<p align="center">Fort Mill School District</p> <p align="center">Addendum #1</p>	Solicitation Number: #23-014 Date Issued: April 23, 2024 Procurement Specialist: Kelly Keniston Phone: (803) 548-8202 E-Mail Address: kenistonk@fortmillschools.org	
---	--	---	--

DESCRIPTION: Fort Mill School District: Paving Projects

Addendum #1 is being issued to update specific bid schedule information, answer questions received from bidders, and issue minutes from the pre-bid meeting.

Proposed locations of Cores / Samples / Testing / etc.

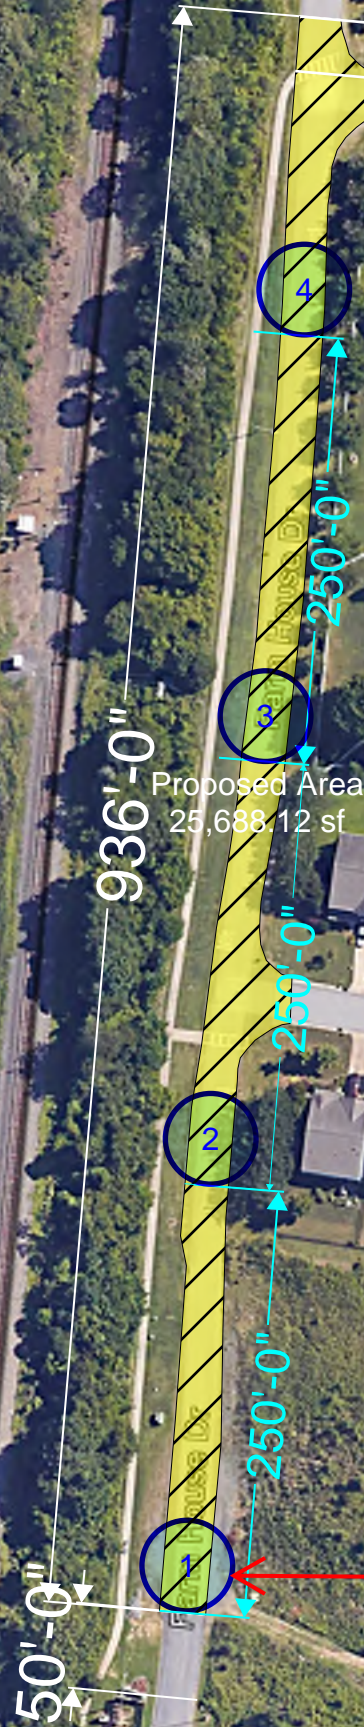
Proposed area of Farmhouse Rd to be Demo'd / Replaced: 25,690sf OR 2,855syd

These are the locations where the (4) cores shall be performed. Per YC they requested a max of 250-300Lft between locations.

(5) Aisle Striping Plan

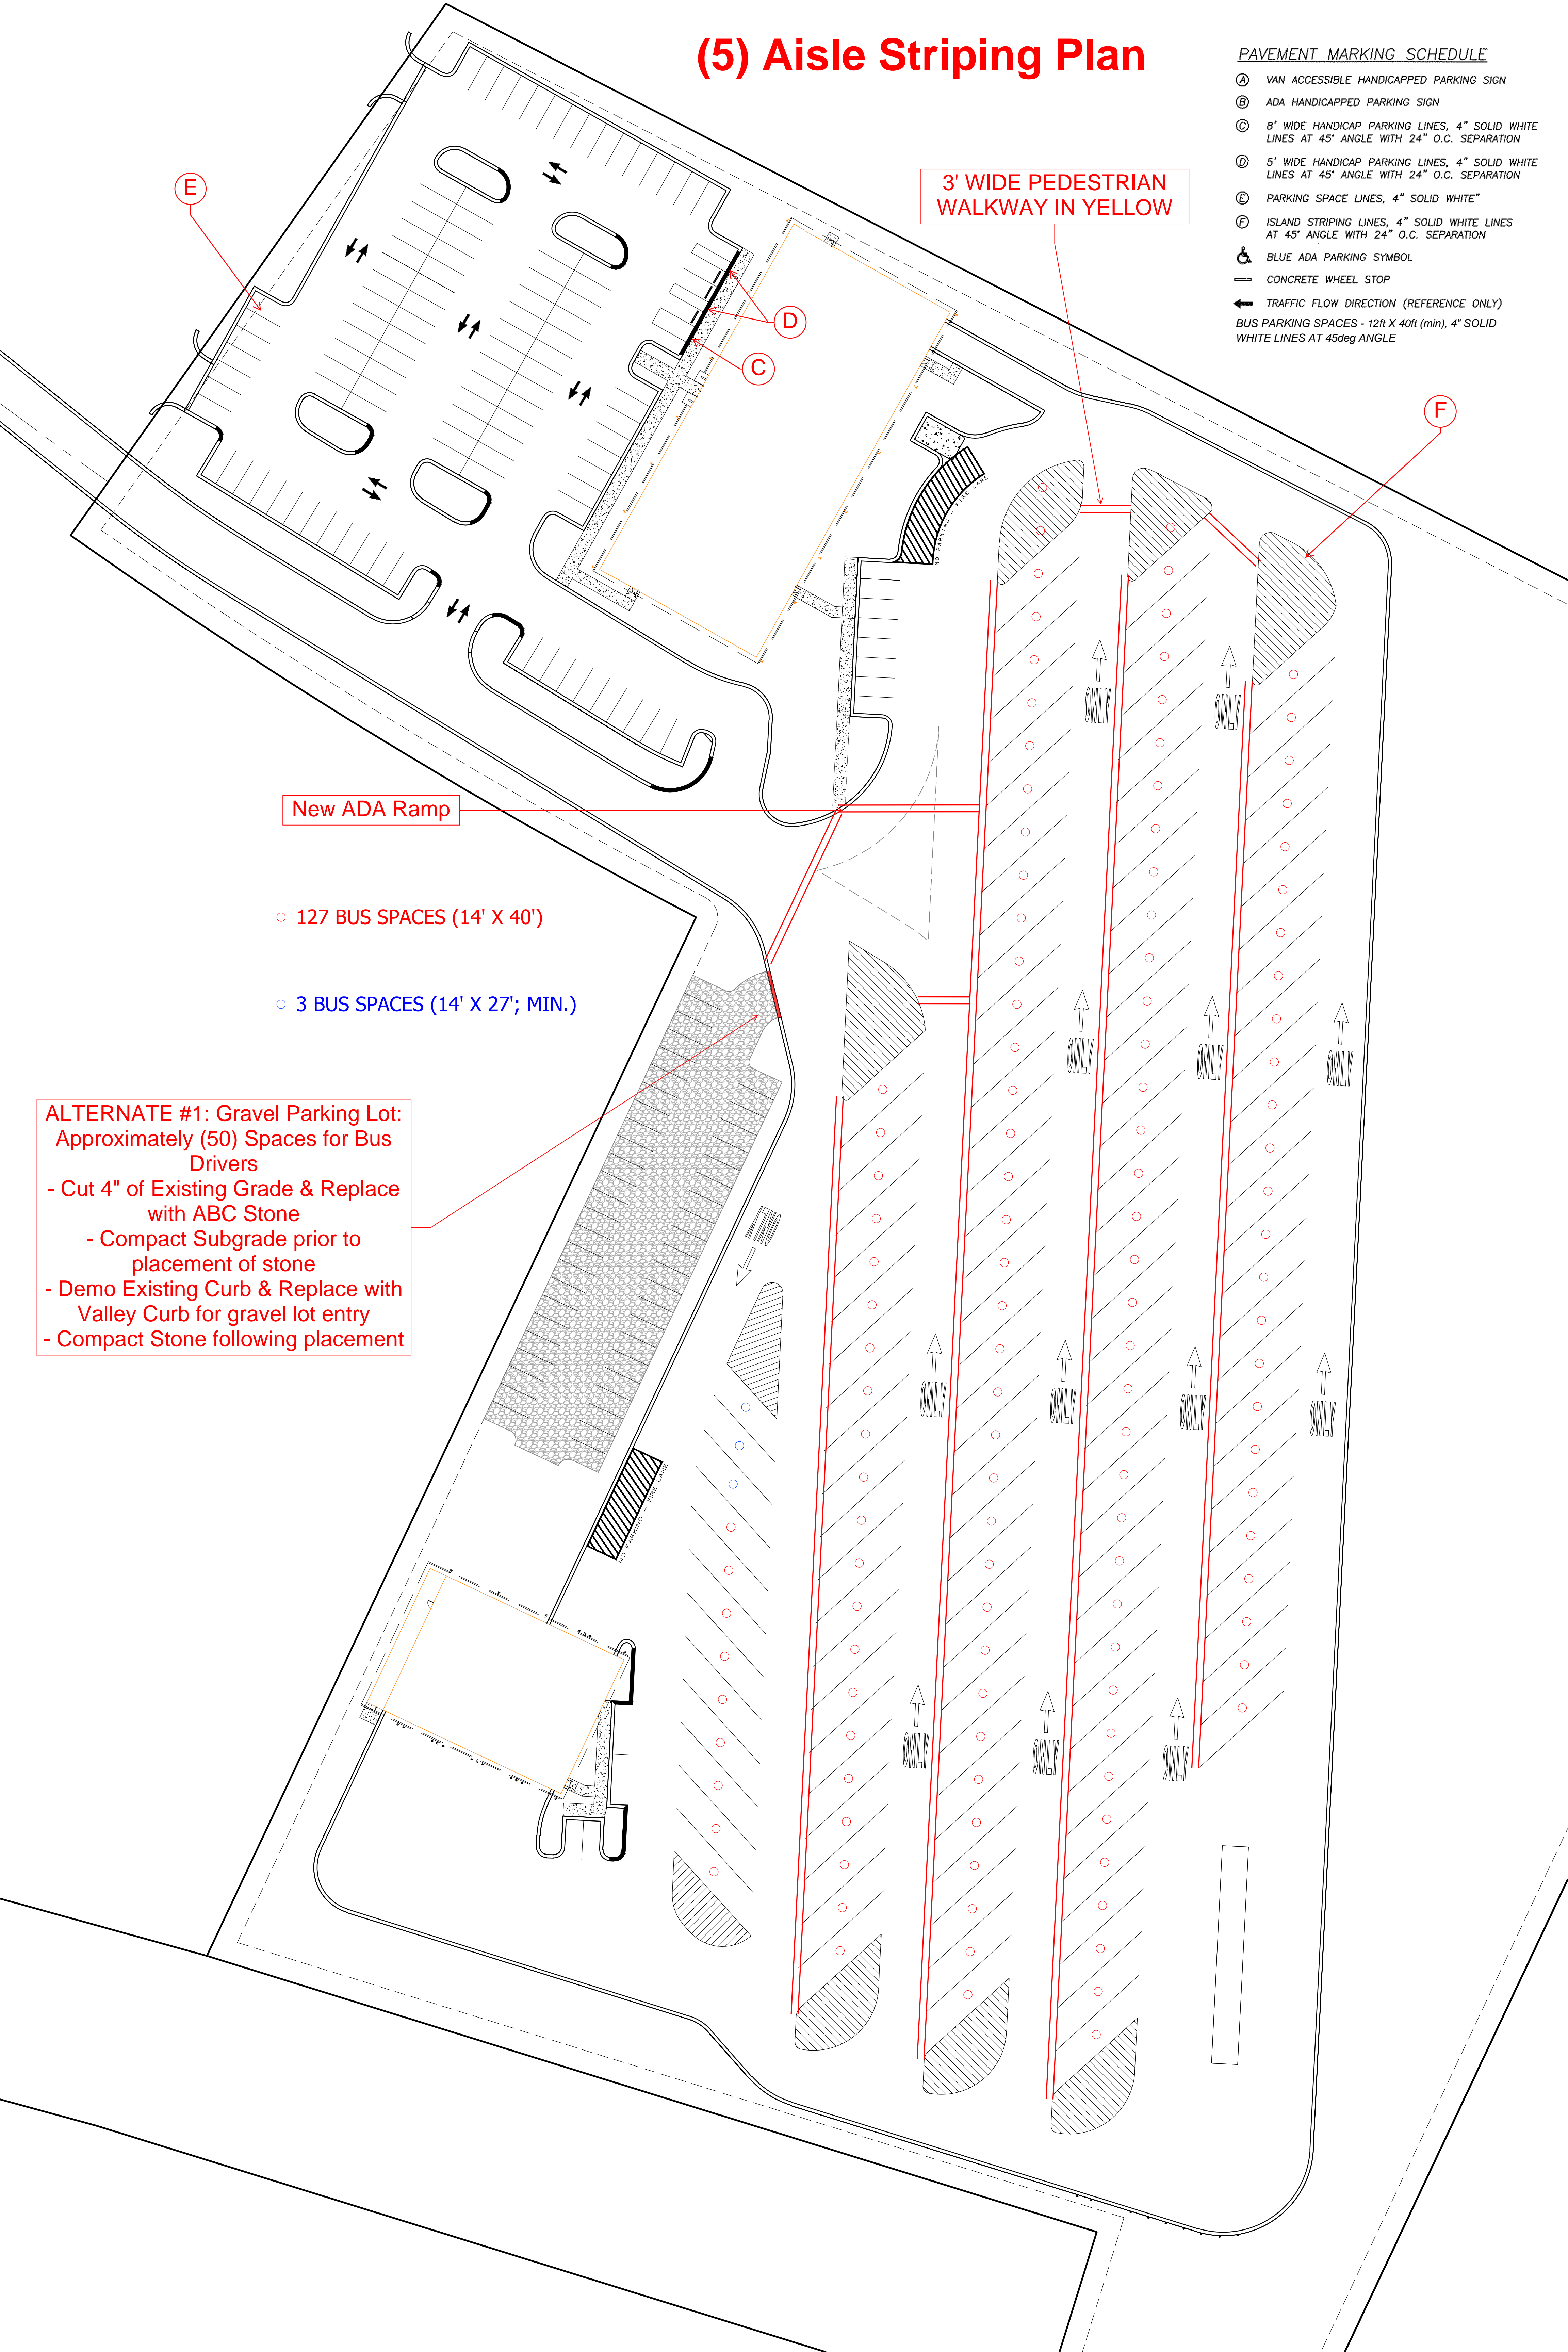
- Perform all necessary striping as indicated per Sheet C4.0.
 - Striping scope shall include entire Car and Bus parking and drive areas as indicated.
 - Car Parking – 116 Spaces

- Bus Parking – 140 Spaces
 - All indicated traffic directional marking and islands as indicated.
 - **Provide 3'-0" wide pedestrian walkway as indicated.**

3' WIDE PEDESTRIAN WALKWAY IN YELLOW

C103A

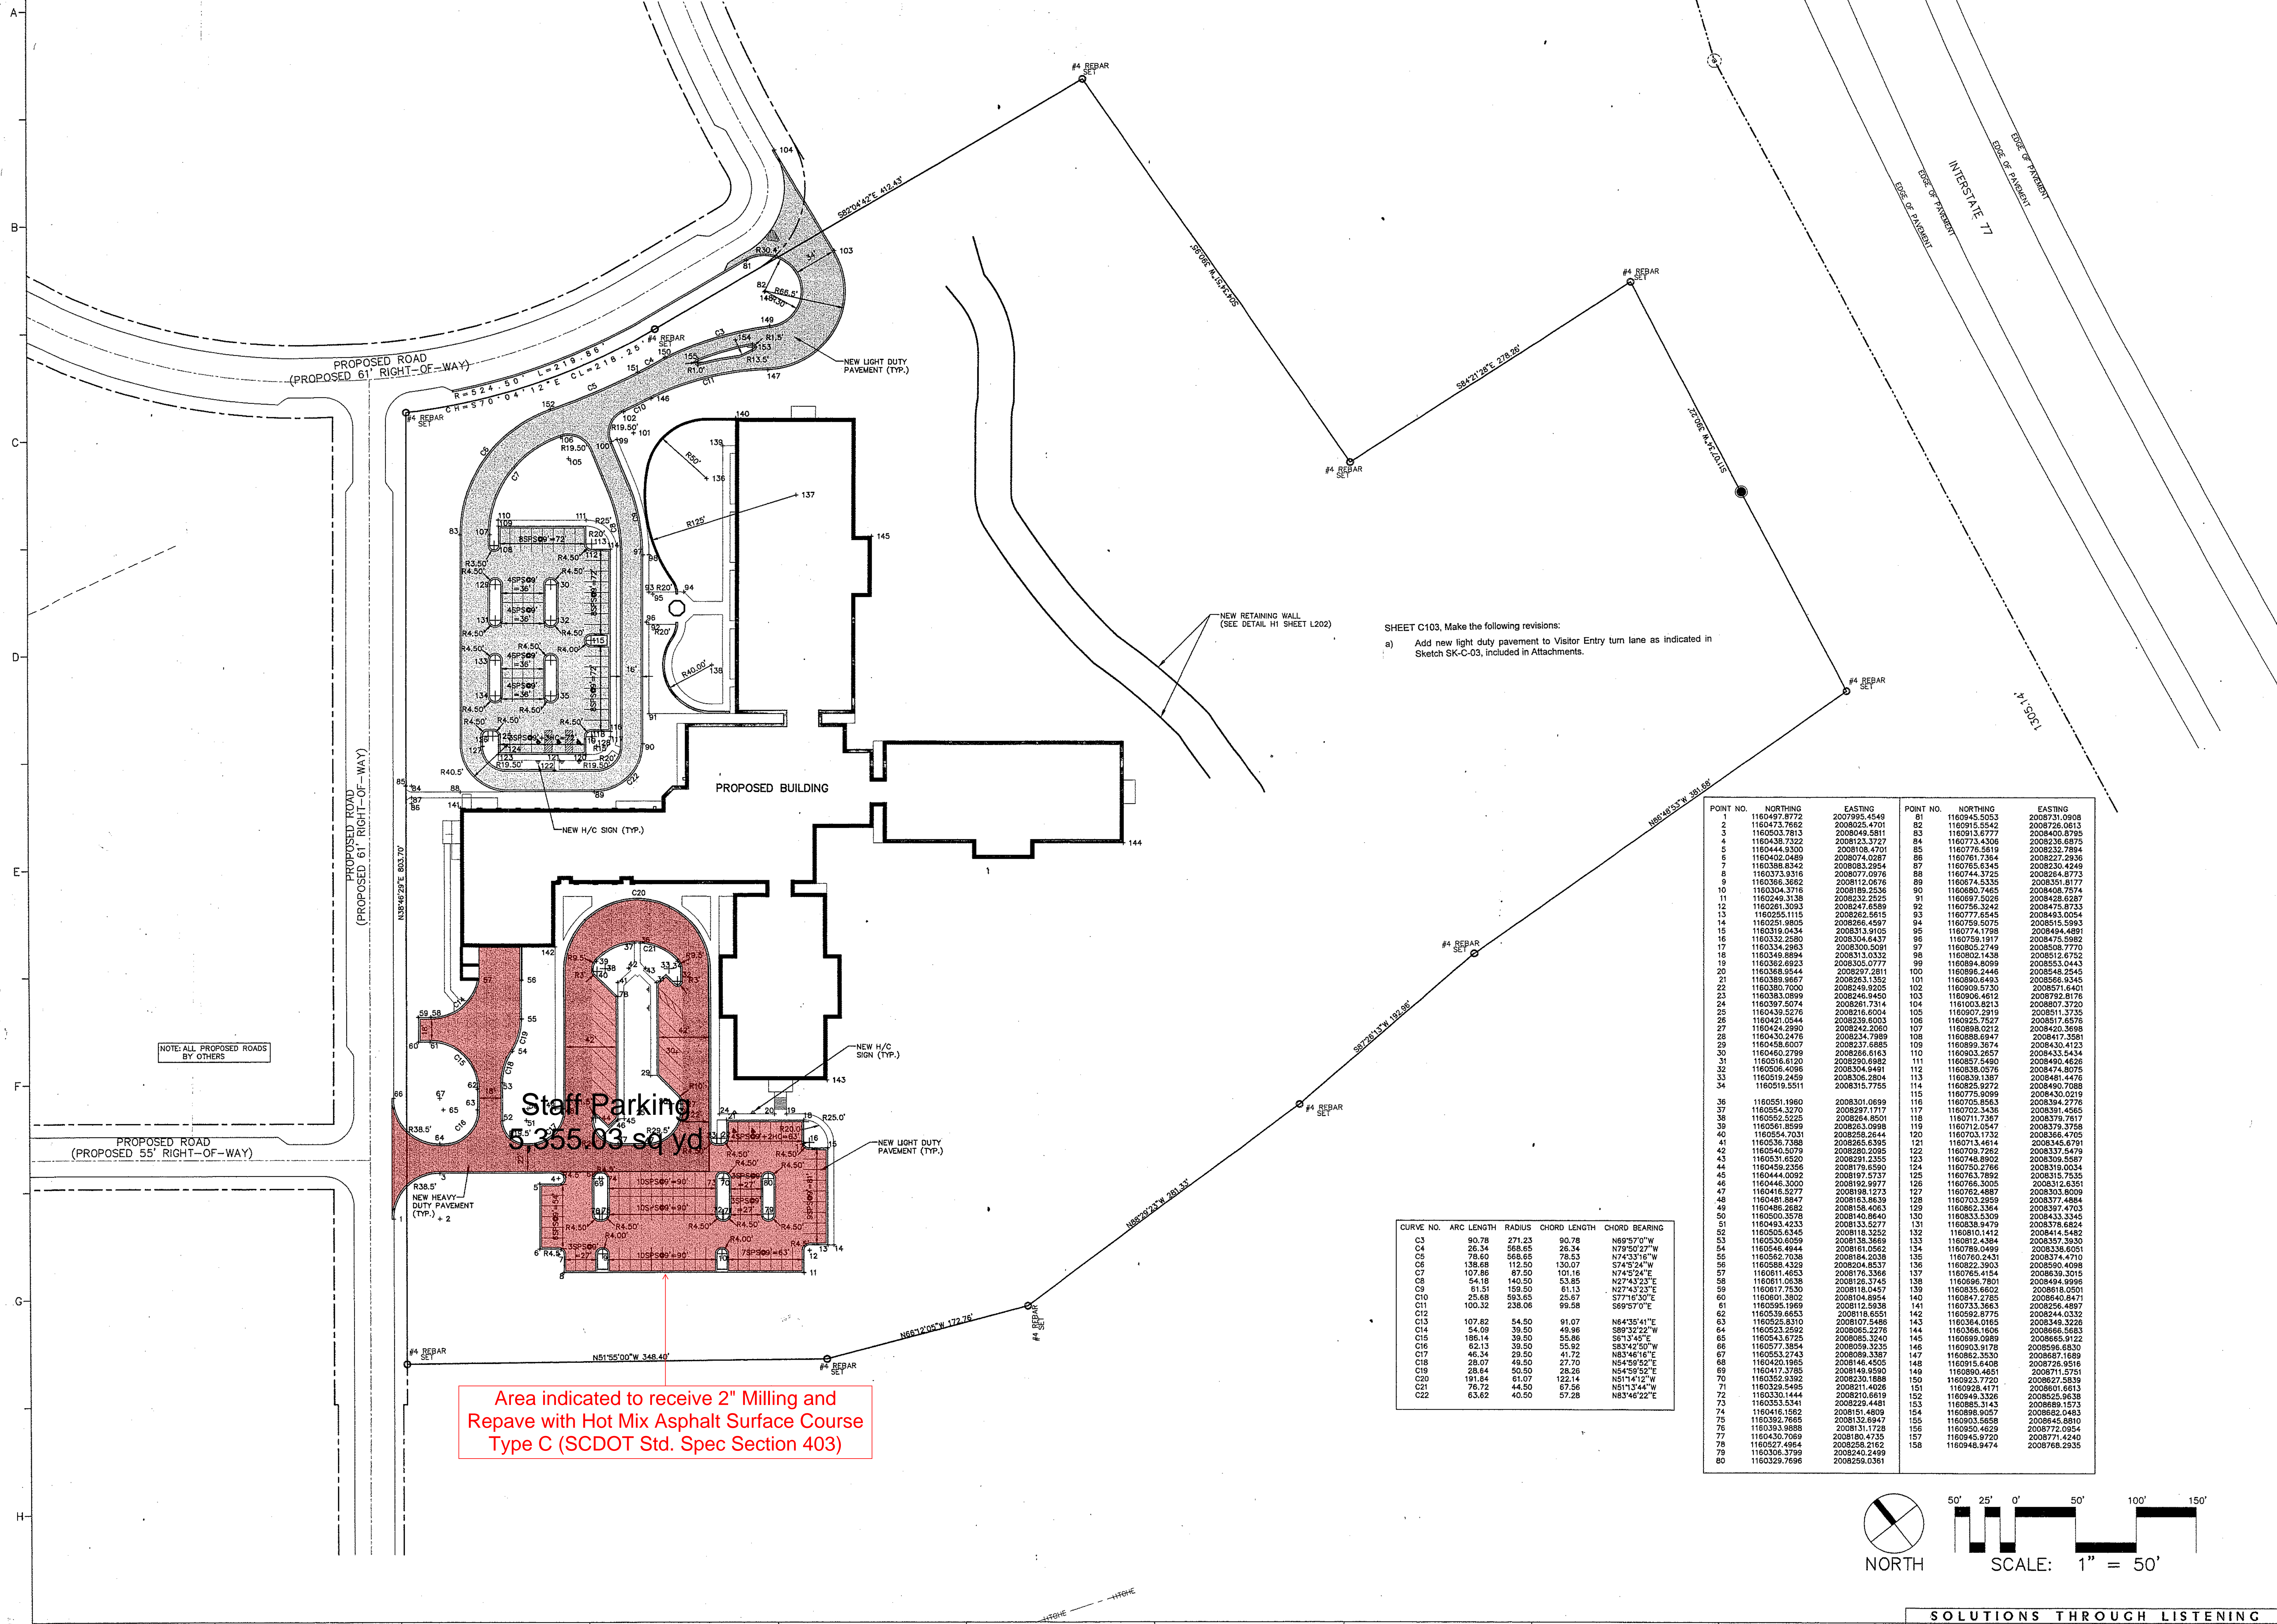
- Scope to include:
 - Cut and Replace approximately 20sy of asphalt as shown on Sheet C103A of Attachment C.
 - **Mill identified area of existing pavement 2" and replace with 2" Hot Mix Asphalt Surface Course, Type C (SCDOT Std. Spec Section 403)**

Area indicated to receive 2" Milling and Repave with Hot Mix Asphalt Surface Course Type C (SCDOT Std. Spec Section 403)

CUT OUT AND REPLACE APPROX. 20SY OF ASPHALT RUTTING. SEE PICTURE & HEAVY DUTY CROSS SECTION ON FOLLOWING PAGE

HEAVY DUTY ASPHALT PAVEMENT DETAIL
NOT TO SCALE

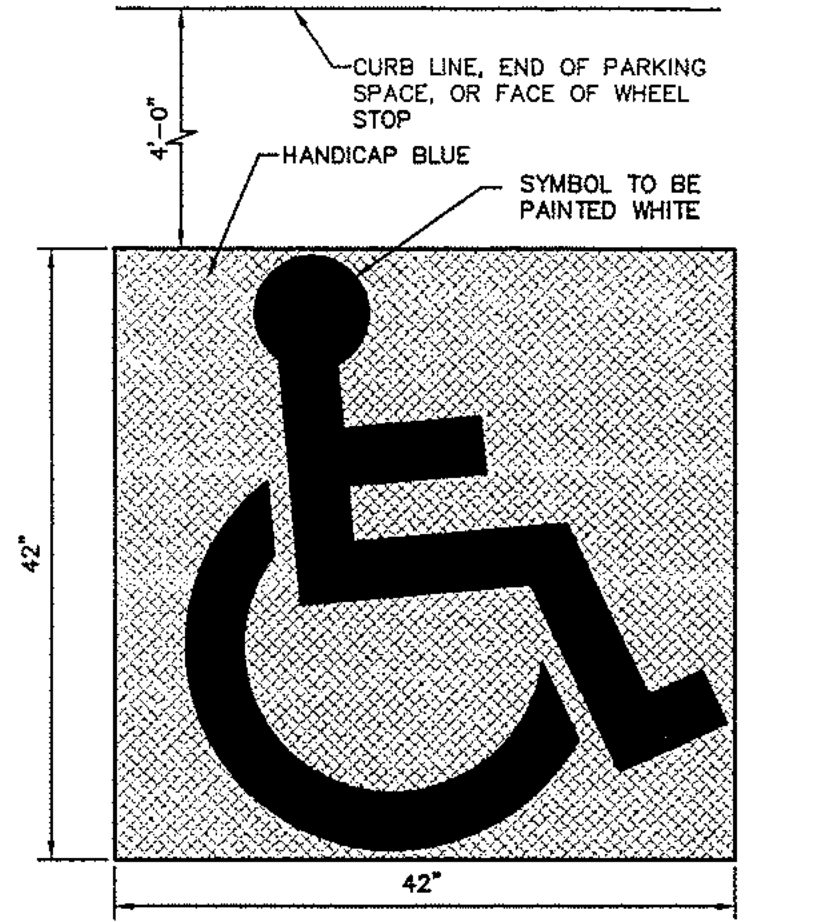
- Q:** A pavement cross section of the area shown to be cut and replaced at OPES was requested?
- A:** The cross section of the existing pavement is located on sheet C105 of Package C for reference. The cut and patch of this area should match the original cross section or approved full depth asphalt replacement.
